From: Wickham, Jerry, Env. Health
Sent: Wednesday, February 24, 2010 1:48 PM
To: 'Erik Appel'
Cc: Bryan Campbell
Subject: RE: 74121 - 10605 Foothill Blvd. Excavation

SITE MAP SHOWING EXTENT OF PROPOSED EXCAVATION
 FORMER EXXON RS 74121
 10605 FOOTHILL BOULEVARD, OAKLAND, CALIFORNIA
 27 MARCH AND 23 APRIL 2009

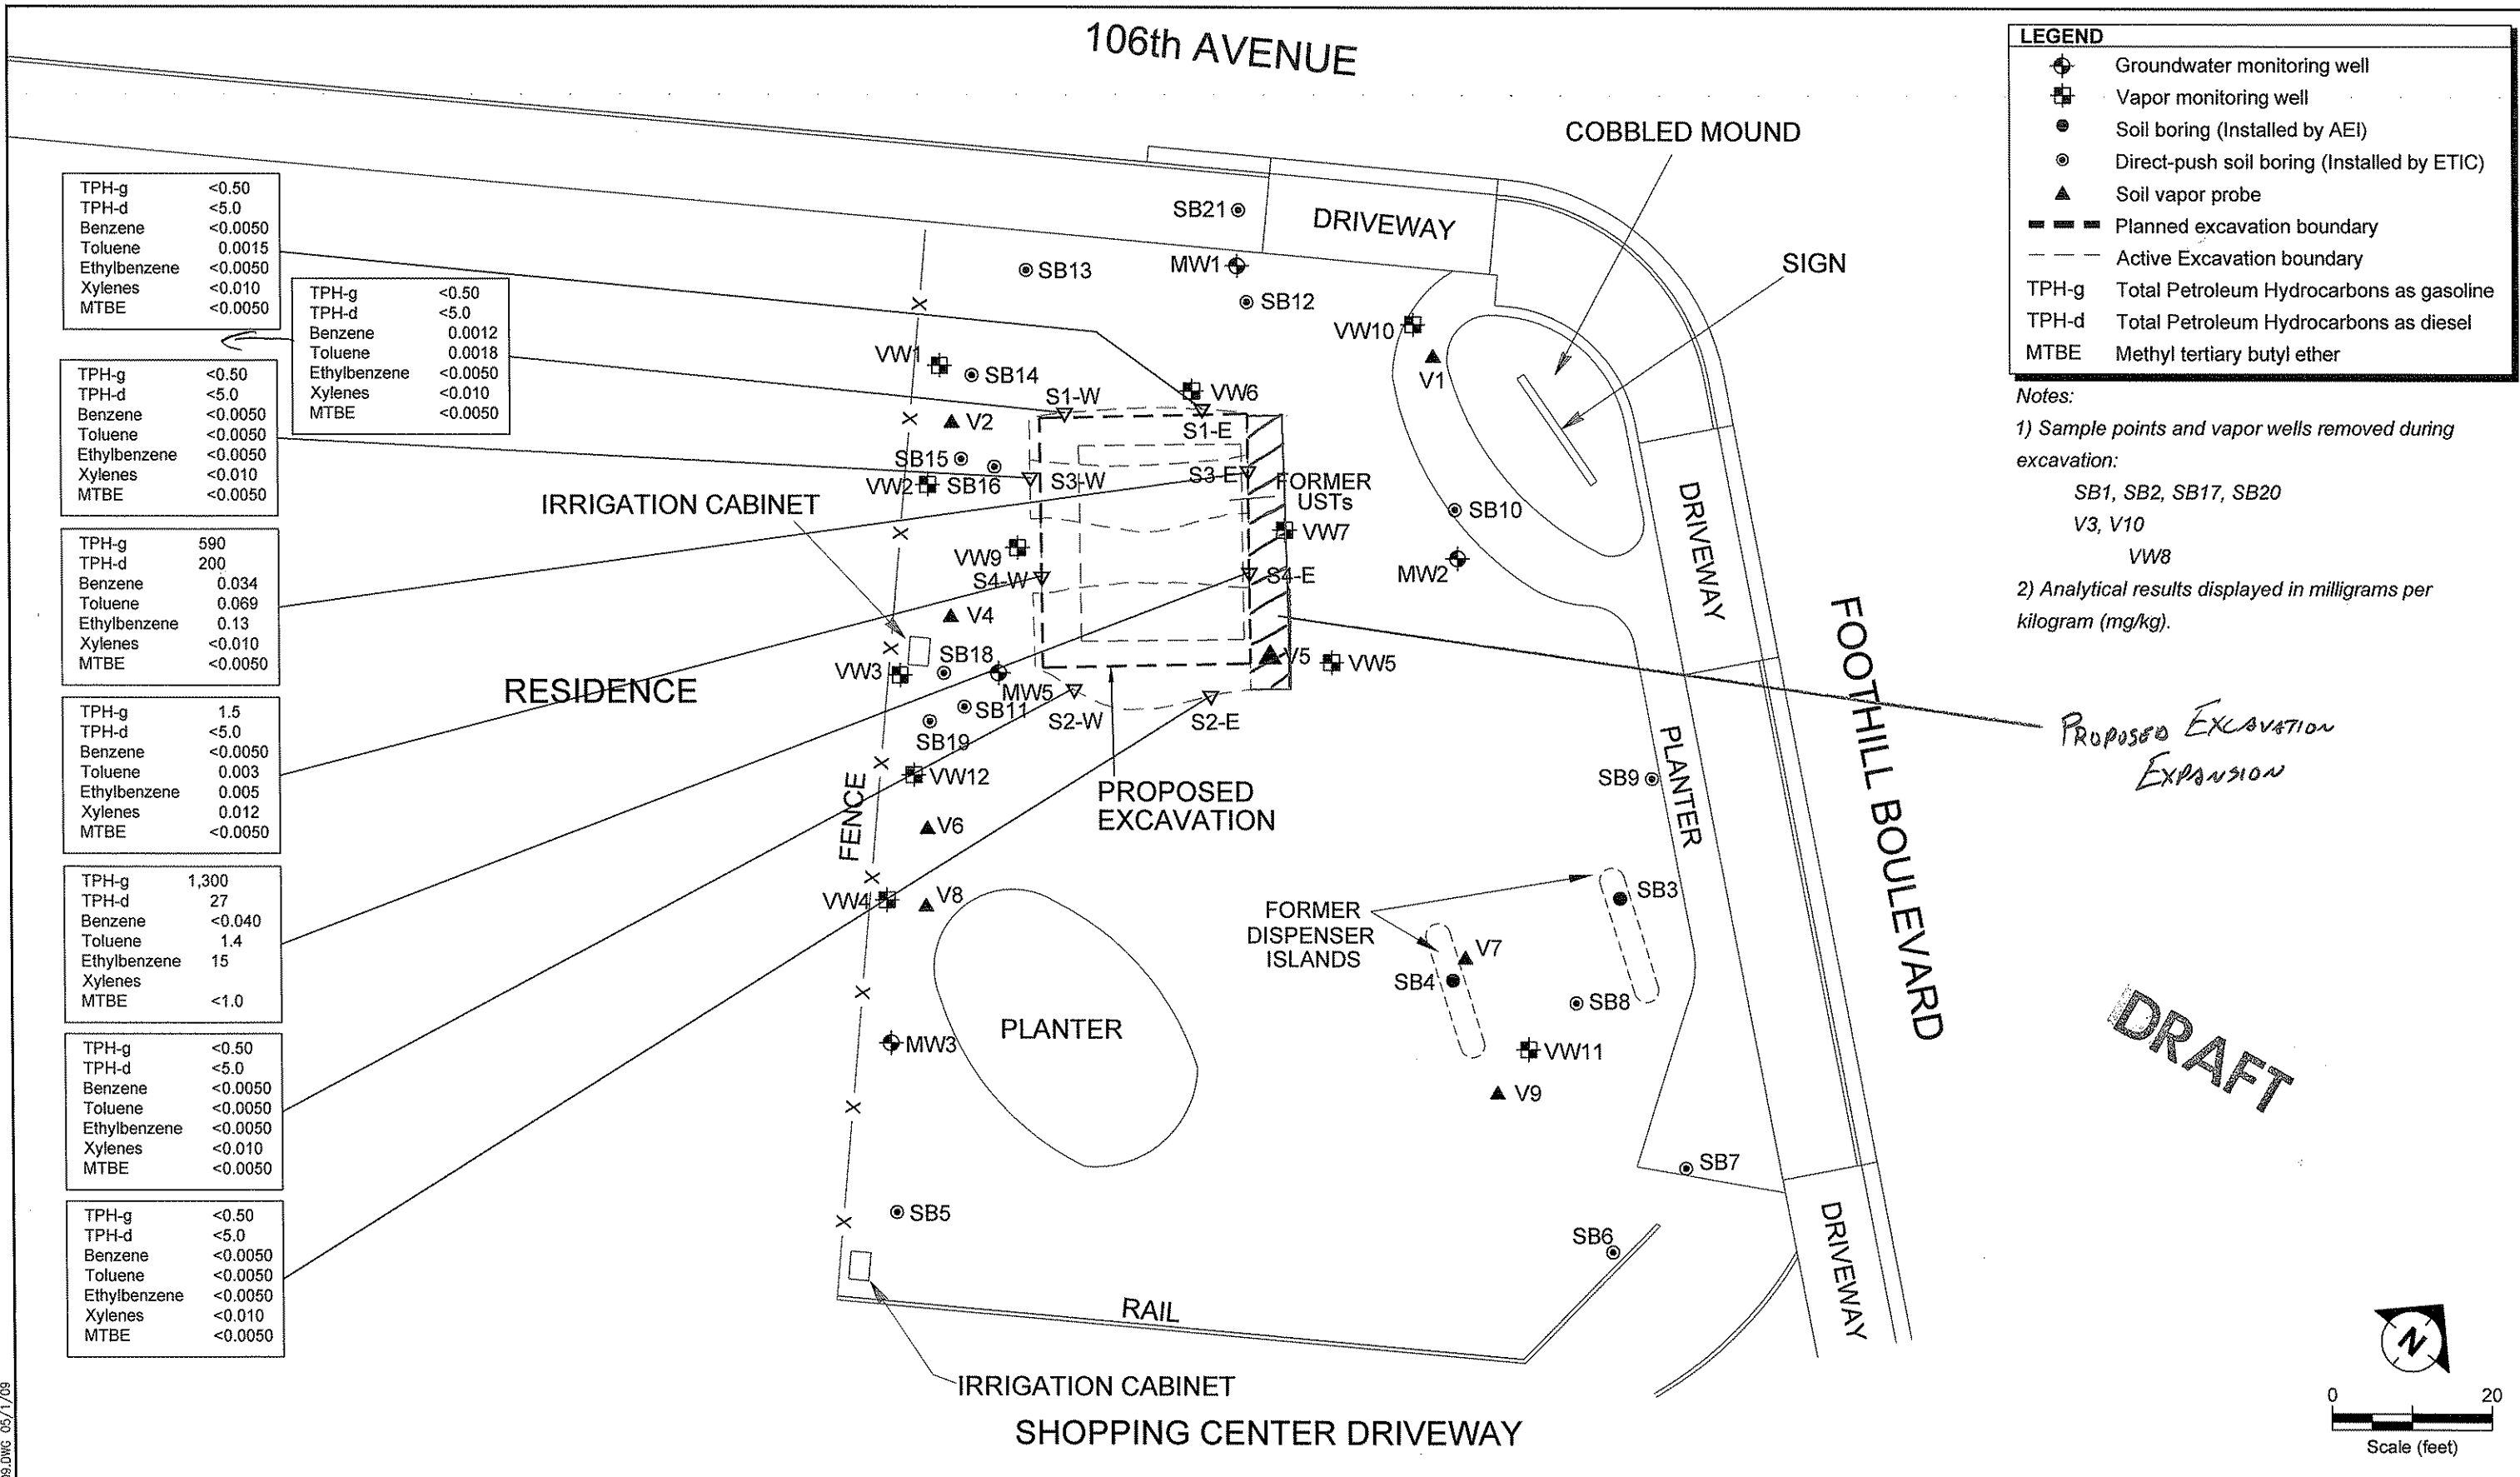
Attached is the figure of our present excavation with analytical results at the indicated location. We intend to expand a 5-foot slot on the northeast side of the present excavation.

Please let me know if you concur.

I concur with expanding the excavation. Following expansion of the excavation, please collect confirmation soil samples from the expanded sidewall at the depth where the highest PID readings, odor, or visual contamination were observed during excavation.
